IEEE P802.3da Comments #100-109 (Power-ODVA) on multiple instances of MPoE per DTE

David D. Brandt, Rockwell Automation

Clause 30 MPSE/MPD management changes

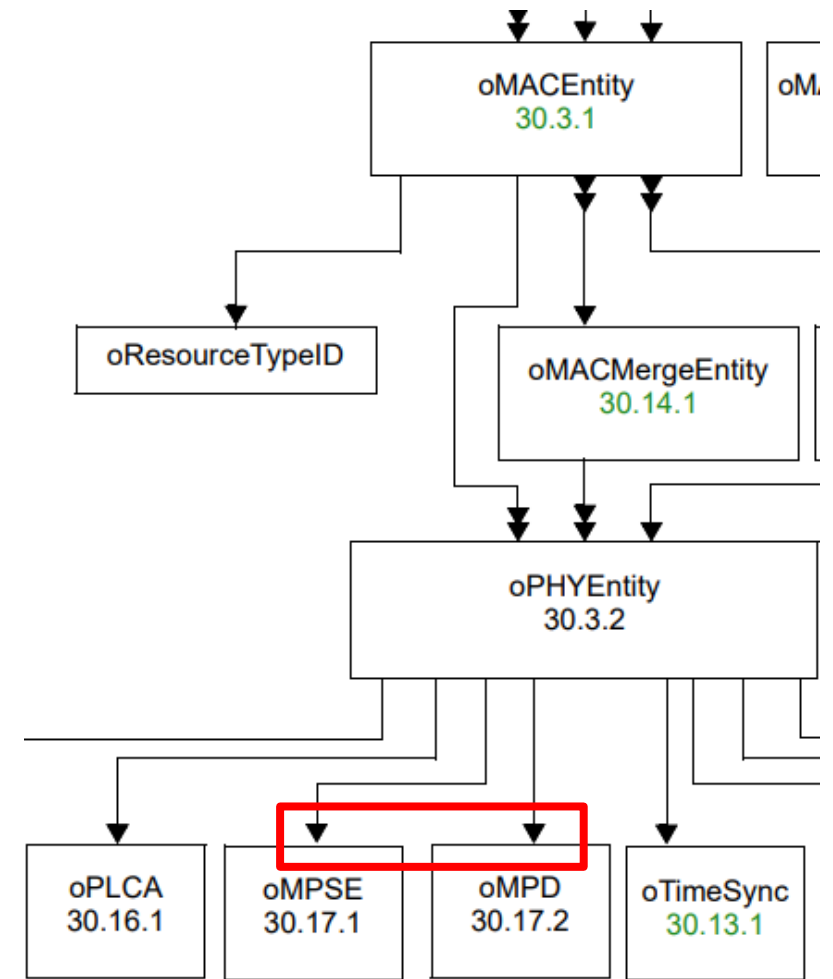
- #103: Extend oPHYEntity with double arrowheads to contain one or more oMPSE and oMPD
- #104, 105: Add instance identifiers.

30.17.1.1.1 aMPSEID

A read-only value that identifies a specific MPSE interface that is associated with an oPHYEntity.

0 = co-resident data and power interface

1-3 = separate power interfaces;

30.17.2.1.1 aMPDID

A read-only value that identifies a specific MPD interface that is associated with an oPHYEntity.

0 = co-resident data and power interface

1-3 = separate power interfaces;
